Making sense of Annex 178B

Proposed revisions to Annex 178B

Figure 178B–1—ISL and Path

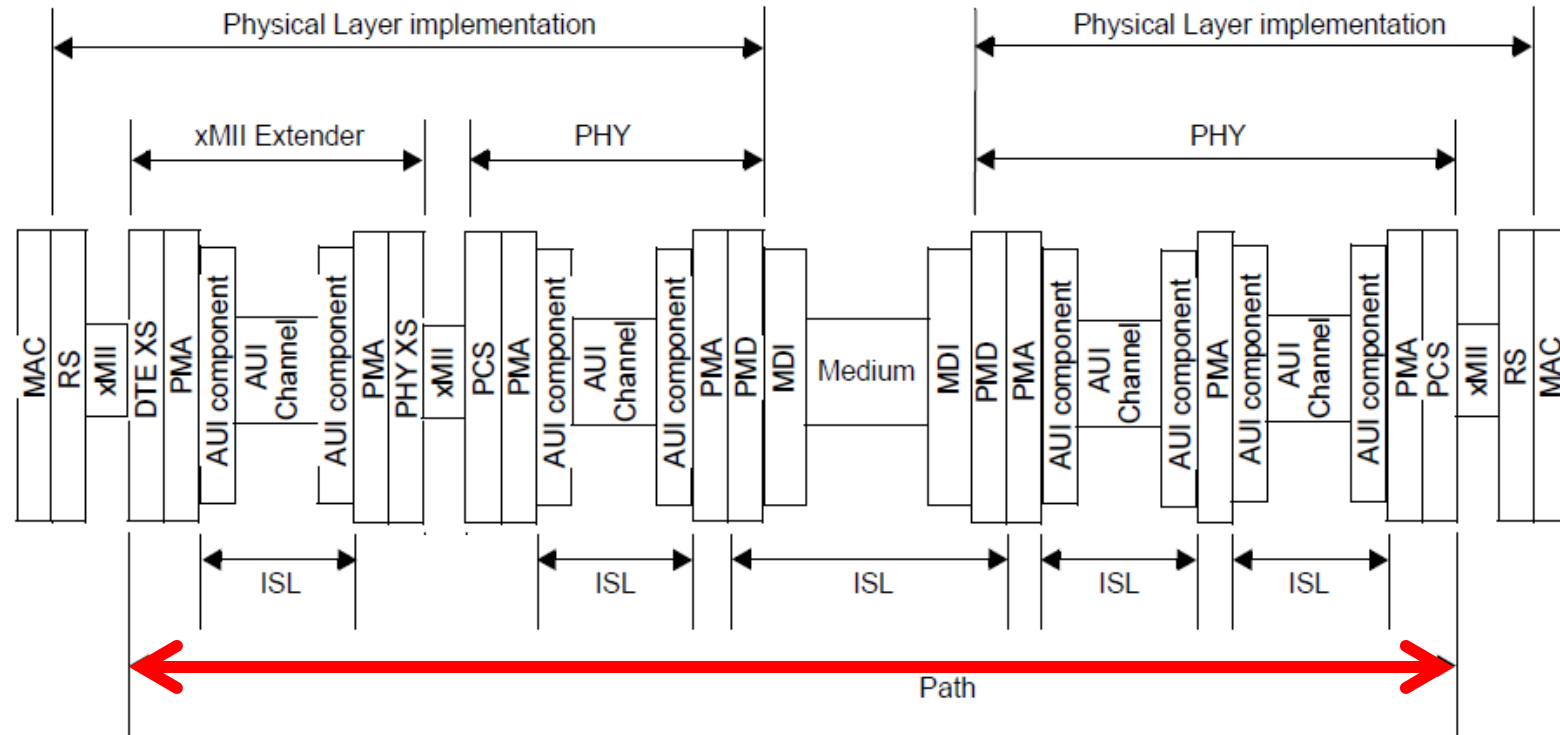
Intended “Path” in Annex 178B is RS to RS

Although this is effectively the same as the general definition in 1.4.455, it might be helpful to rephrase it in the context of ILT and path start-up:

Path -- The sequence of ISLs and intermediate sublayers providing the connectivity between two Reconciliation Sublayers. See Figure 178B–1.

Figure 178B-2—ILT function in AU1 components and PMDs

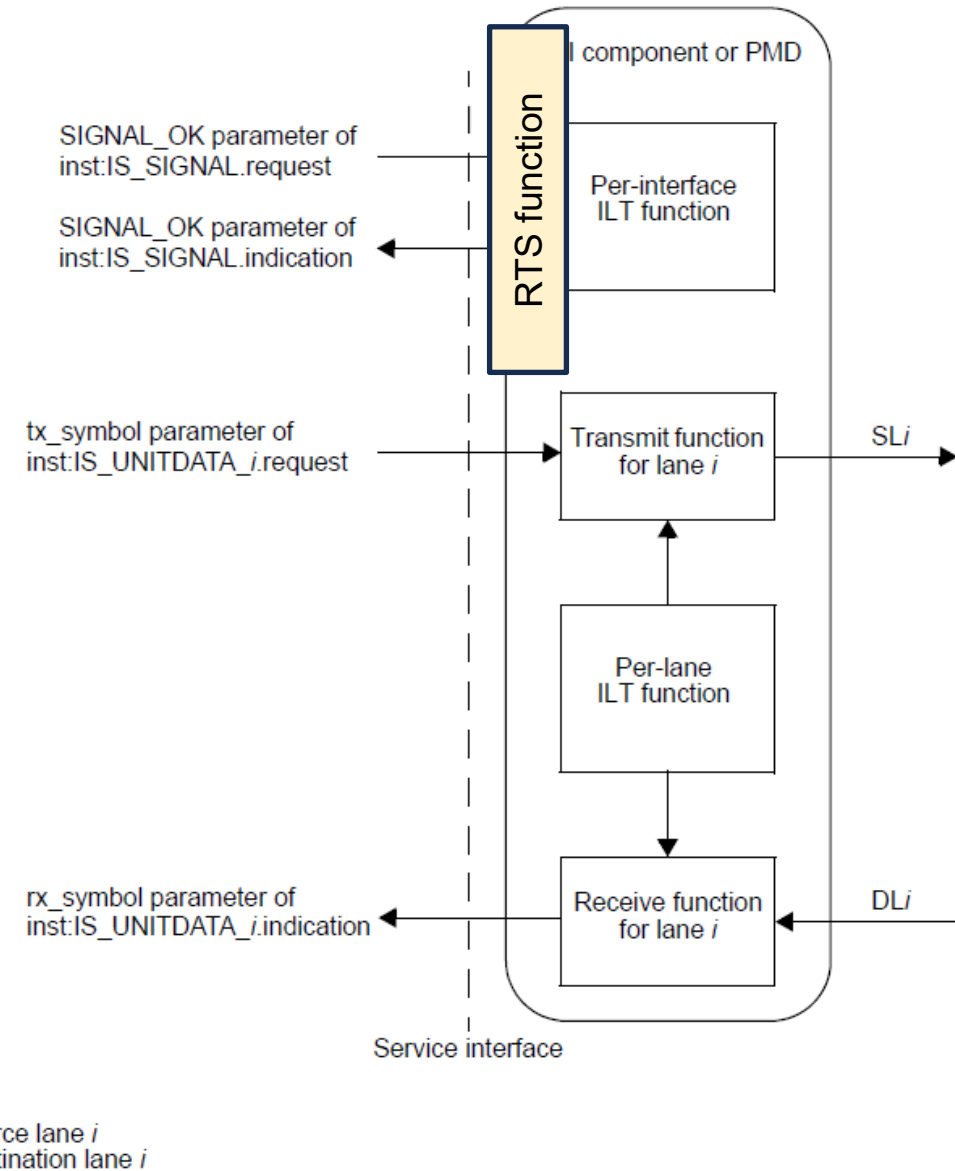
Figure 178B-2

Figure 178B-2 would need to be updated to show:

- input SIGNAL_OK parameter is processed by the RTS function
- coordinates transmitter clock and data cutover
- the RTS status bit in the training frame is controlled by the RTS function

Update to the right is an approximate illustration.
